Renishaw CMM Products Division PRODUCT BULLETIN – PBC1624

Product: UCC Software	Status: Open
Title: Launch of UCCsuite 4.5	Date: 24 th October 2012

PH20 metrology improvements

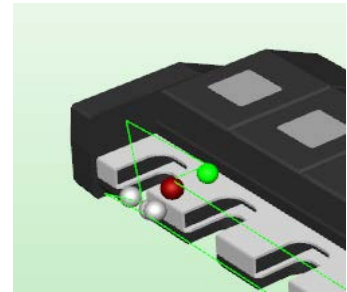
Significant improvements to the PH20 calibration have been made in version 4.5. Previous versions exhibited problems with the matching of tip size, depending on whether taking Head touches or CMM touches and could be susceptible to false triggers. Version 4.5 now has the following improvements:

- A pre-travel variation (PTV) map is added for CMM touches, thereby improving the form performance for CMM touches at different angles of touch. V4.4.9 only had a PTV map for Head touches.
- Tip size derivation is improved to give a better single tip size which is valid for both touch methods (Head touch and CMM touch).
- Establishment of the 0 degrees (straight down) position of the A-axis (A-axis Offset) is improved giving better size measurements for Head touches below the critical angle, i.e. when measuring vertical bores. Tip correction will still be required to correct the A-axis offset that may result from the mechanical repeatability seen after

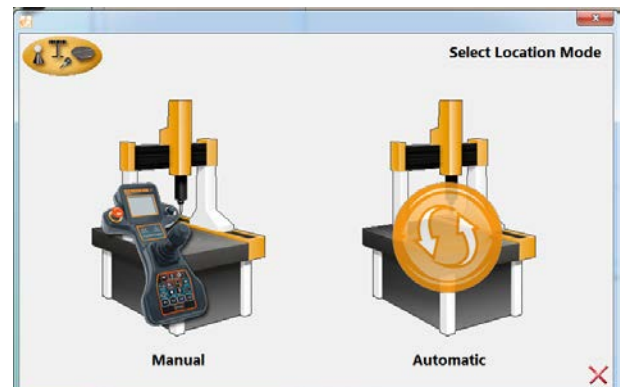
- UCCsuite 4.5 includes an overhaul of its rack alignment routines/GUI. Initial joystick alignment is guided by a bouncing ball graphic. The red ball is the next point; the green ball represents taken points.

- After joystick alignment, the user is presented with a choice of old "Manual" method for each port or CNC "Automatic" for all ports.
